UNITED STATES DEPARTMENT OF COMMERCE United States Patent and Trademark Office Address: COMMISSIONER FOR PATENTS P.O. Box 1450 Alexandria, Virginia 22313-1450 www.usplo.gov

APPLICATION NO.	FILING DATE	FIRST NAMED INVENTOR	ATTORNEY DOCKET NO.	CONFIRMATION NO.
10/530,563	04/07/2005	Takao Hasegawa	040894-7216	8997
9629 7590 08/30/2007 MORGAN LEWIS & BOCKIUS LLP			EXAMINER	
	LVANIA AVENUE N N. DC 20004	1	REYNOLDS, STEVEN ALAN	
WASHINGTON, DC 20004			ART UNIT	PAPER NUMBER
			3728

Application No.	Applicant(s)			
OFF 4 4 5	10/530,563	HASEGAWA ET AL.			
Office Action Summary	Examiner	Art Unit			
	Steven Reynolds	3728			
The MAILING DATE of this communication a Period for Reply	ppears on the cover sheet w	ith the correspondence address			
A SHORTENED STATUTORY PERIOD FOR REP WHICHEVER IS LONGER, FROM THE MAILING - Extensions of time may be available under the provisions of 37 CFR after SIX (6) MONTHS from the mailing date of this communication. - If NO period for reply is specified above, the maximum statutory perions are provided by the communication of the provided period for reply will, by status and the provided period for reply will, by status and patent term adjustment. See 37 CFR 1

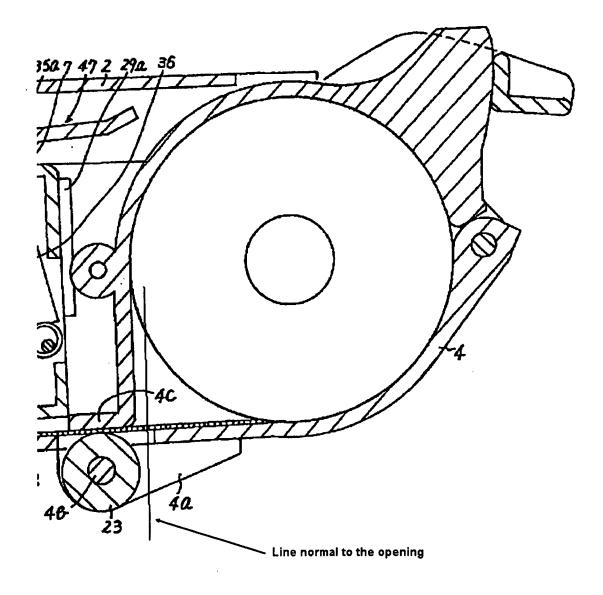
Examiner interprets the limitations in claim 10 as the opening being normal to a circumferential surface of the roll staple; this can be shown by a normal line drawn through the opening, which touches a portion of the circumferential surface of the roll staple (this can be seen in the portion of Figure 4 shown below).

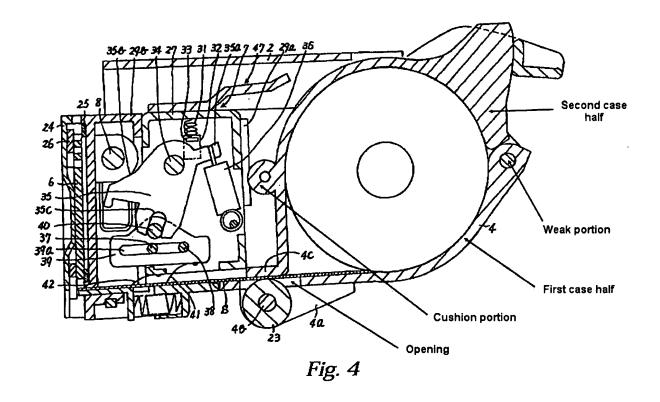
Mochizuki further discloses a pull-out opening (opening wherein staples S pass beneath plate 4 – See Fig. 4 embodiment) through which the roll staple is pulled out; a cushion portion (See figure below); a portion for positioning in a containing chamber (45 slides into 43 to position the cartridge into the containing chamber 2); a guide portion for guiding the staple case to a containing chamber (46 slides into 44 to guide the cartridge into the containing chamber 2); a first case half and a second case half (See Figure

below); a first opening (opening wherein staples S pass beneath plate 4 – See Fig. 4 embodiment) through which the roll staple is pulled out; and a second opening (opening in lower portion of cartridge 4 wherein roller 23 is positioned – See Fig. 4 embodiment and Figure below) through which a member for rotating the roll staple is brought into contact with the roll staple, wherein the first opening is provided on the second case half, and the second opening is provided on the first case half (See Figure below); and a weak portion (hinge – See Figure below) on a joint between the first case half and the second case half.
